Relatório de análise de contribuições referentes à Audiência Pública nº 19/2017 - Proposta de edição de emenda ao Regulamento Brasileiro da Aviação Civil nº 154 (RBAC nº 154), intitulado “Projeto de Aeródromos”.

Audiência Pública nº 19/2017	Processo nº 00058.524342/2017-10																												
Assunto: Proposta de edição de emenda ao Regulamento Brasileiro da Aviação Civil nº 154 (RBAC nº 154), intitulado “Projeto de Aeródromos”.																													
Contribuição nº 1																													
Dados do colaborador																													
Nome: Daniel Chaves Ribeiro																													
Categoria: Operador Aéreo																													
Trecho da minuta a discutir ou aspecto não previsto que se propõe abordar																													
Parágrafo 154.203(b)(3)																													
Texto da Contribuição																													
A Empresa Aérea Emirates analisou a proposta de emenda ao Regulamento Brasileiro de Aviação Civil n 154 conforme Audiência Pública n 19/2017. Gostaríamos de propor alterações nos parágrafos 154.203 (b) (3) e 154.217 Tabela C-5.																													
Justificativa da Contribuição

APC

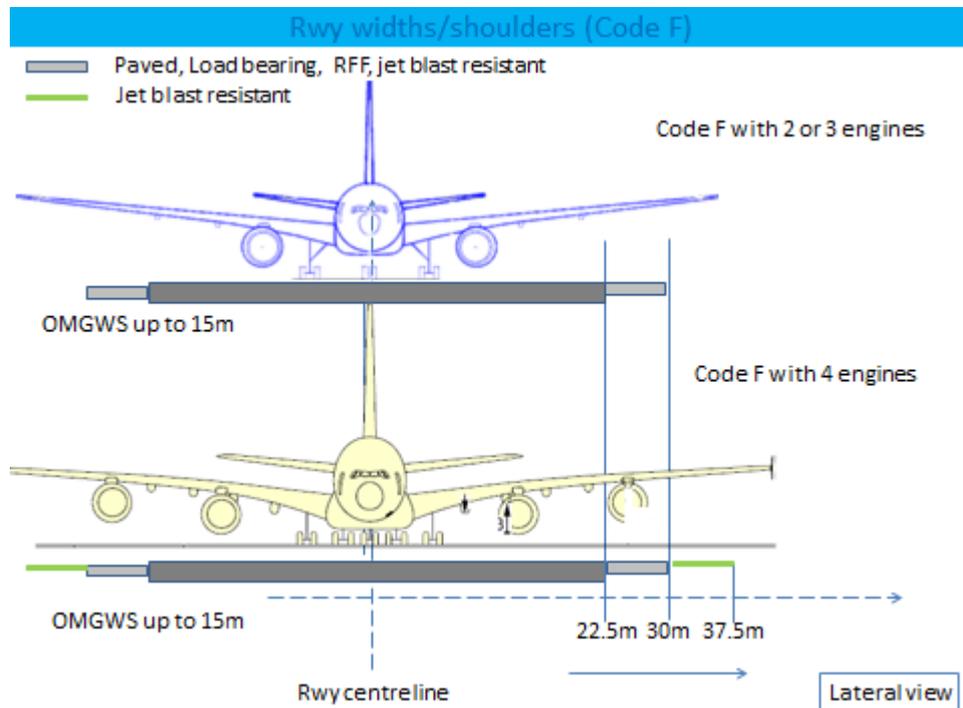
In addition, Emirates provides A380 Pilots with airside color coded charts for destinations and alternate airports that provide additional levels of airside safety and awareness. These have been highly effective, below is a sample of the customized Ground Chart (AGC) and Parking Chart (APC) for the A380 operation in Guarulhos (GRU/SBGR) Airport in line with the special procedures described in the approved Aerodrome Operations Manual.

Operational Limitations		
Airside Element	Designation	Remarks
Total TWY width including shoulder	B, I, J, N, P, DD, FF	Keep the outer engines at idle thrust. The use of onboard camera for taxiing is recommended.
Separation of TWY and RWY	09L/27R-B	During A380 operation on RWY 09L/27R, TWY B should be limited to Code E ACFT. During A380 operation on TWY B, instrument landing on RWY 09L/27R is prohibited.
TWY	Between TWY A and FF	NOT ok for A380.
Parallel TWY Separation	A - B	During A380 operation on TWY A, TWY B should be limited to Code E ACFT and vice versa.
Parallel TWY Separation	A - Apron Taxilane	Apron Taxilane must be restricted to Code E aircraft while A380 on TWY A.
Parking	203	When the A380 is parked at stand 203, stand 202 must be limited to Code D ACFT, stands 204L and 204 must be free of all ACFT and stand 204R must be limited to Code D ACFT.

O interessado argumenta que existem medidas de mitigação que podem permitir a operação de aeronaves código F com distâncias menores que 51m entre o eixo da pista de táxi e um objeto. Embora a ANAC reconheça a possibilidade de adoção pelo operador aeroportuário de tais medidas (a exemplo de estabelecimento de rotas especiais para o A380, restrições de veículos usando vias adjacentes, redução de velocidade nas pistas de táxi, uso de *follow-me*), da mesma forma que explicitado na primeira contribuição, o valor que consta no RBAC 154 é o parâmetro de projeto, que pode ser sopesado com os diversos condicionantes operacionais que podem ser colocados em prática pelo operador do aeródromo com vistas a permitir operações específicas.

Desta forma, os normativos brasileiros (RBAC 139, Subparte F, e RBAC 11) já preveem a possibilidade de operações, em condições especiais, que não atendam ao requisito de projeto previsto no RBAC 154, cumprindo ao operador a demonstração de nível de segurança compatível com a operação.

Assim, esta contribuição também não foi aceita.
